Request for Proposals
Voice over Internet Protocol Unified Communications System
10-2015/2016

PENSACOLA
S T A T E C O L L E G E

Addendum #2, September 22, 2015

Pensacola State College Analog/LYNC Phone Environment

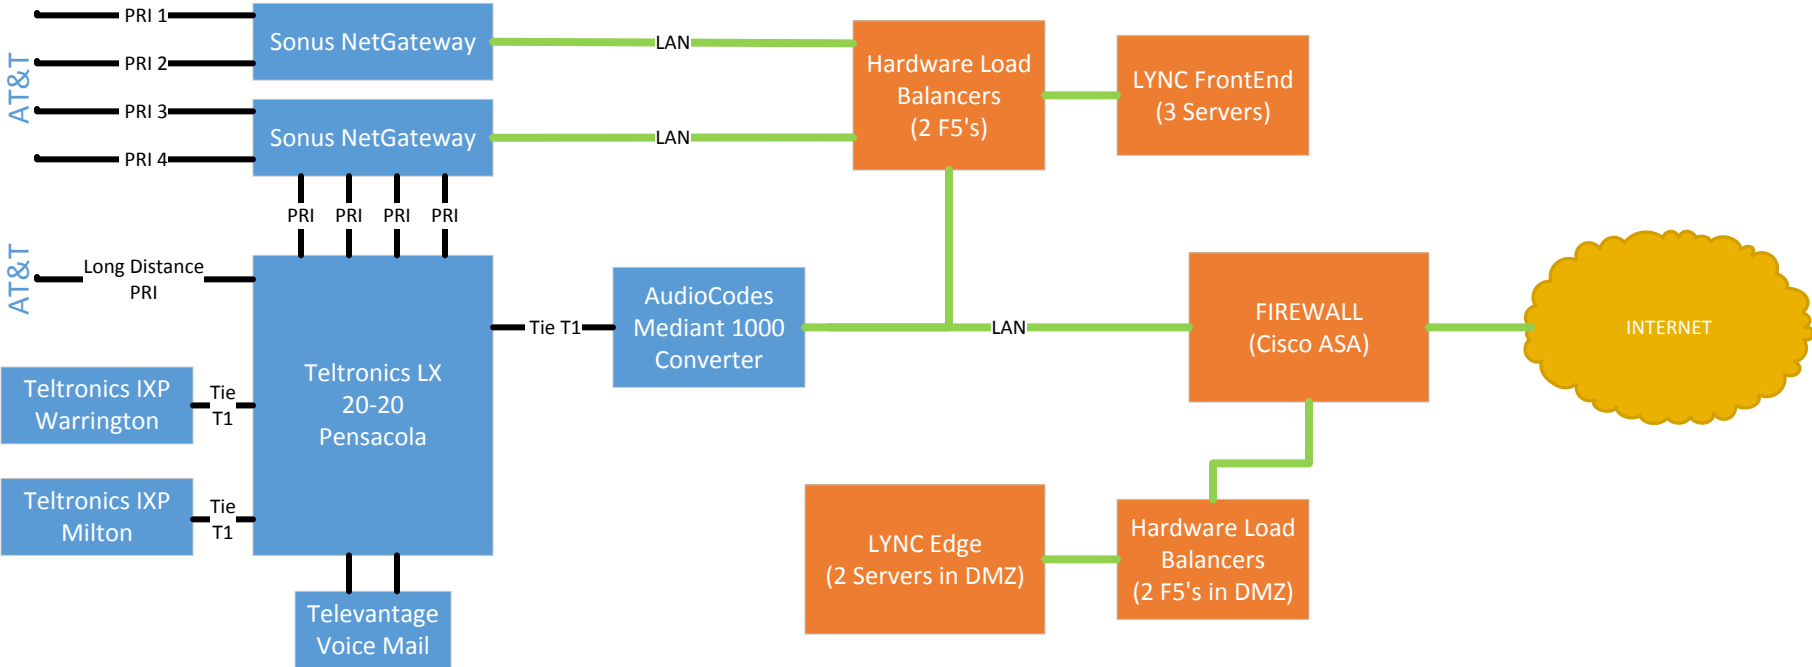
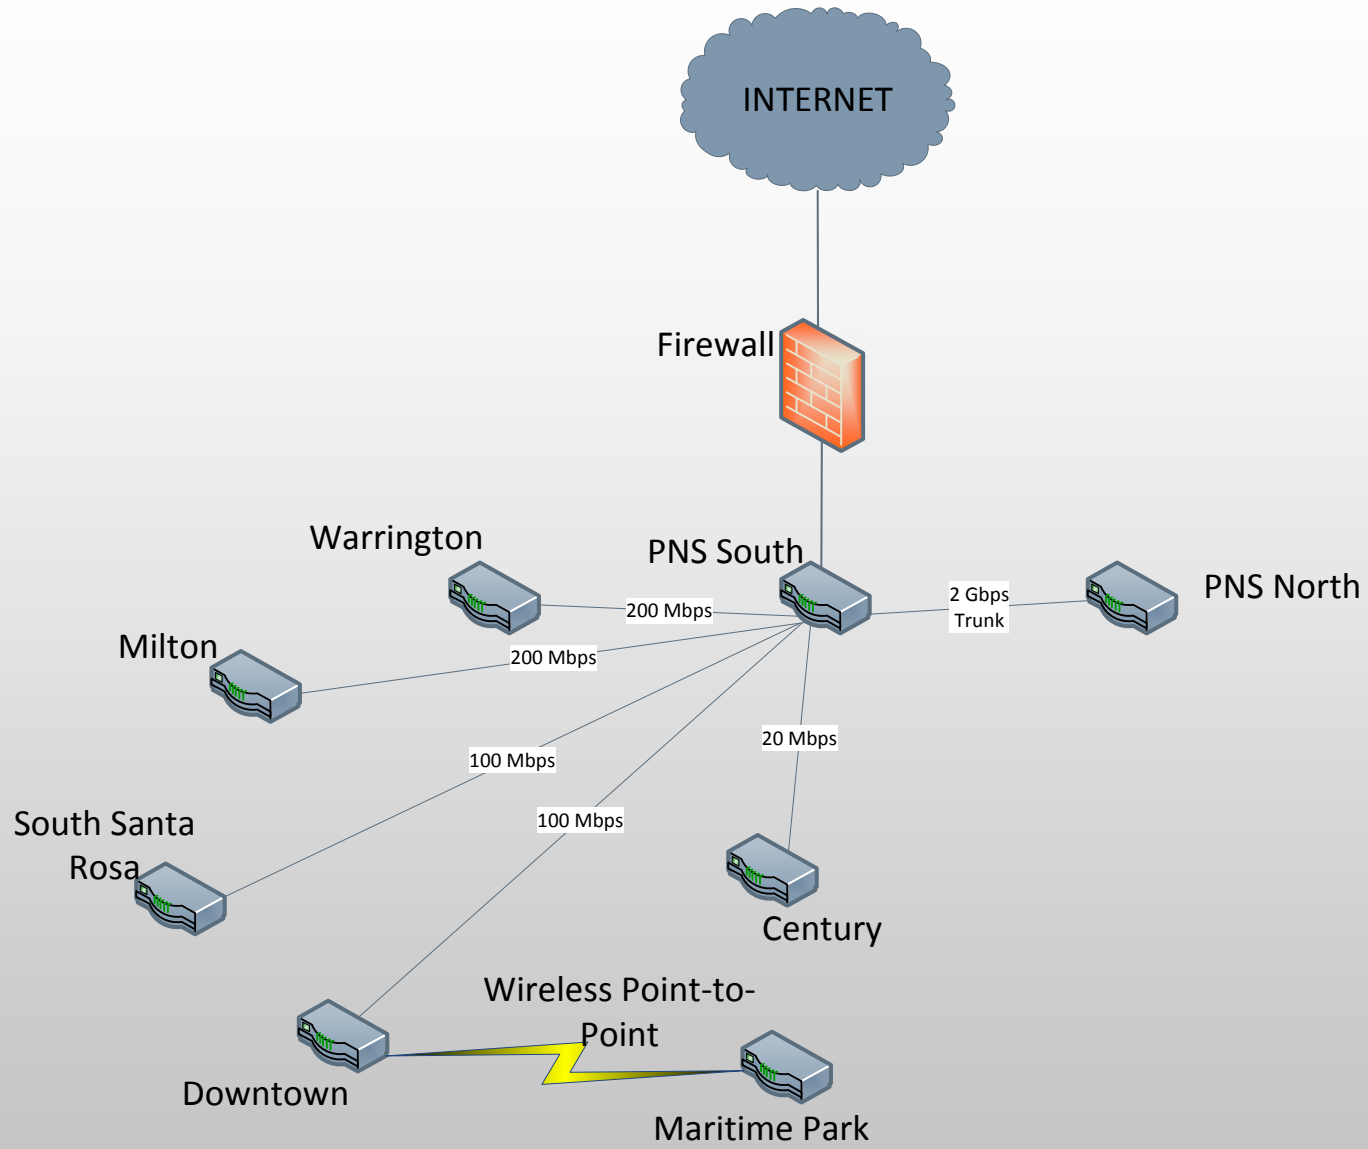
- Question: Is there an electronic drawing that shows the system?
Response: Attached.
- Question: What is the goal of the RFP?
Response: Our goal is to replace our original Harris phone system with a VoIP system.

- Question: Do you still have technicians?
Response: Yes
- Question: Is this an RFI?
Response: No, this is a RFP.
- Question: Does the campus have inter-campus connectivity? If so, please include in addendum drawings.

Response: Attached.
- Question: Are you basically looking for a phone system with switches included?
Response: The College recently upgraded to new POE switches.

Links to perimeter sites are Via SouthernLight Metro
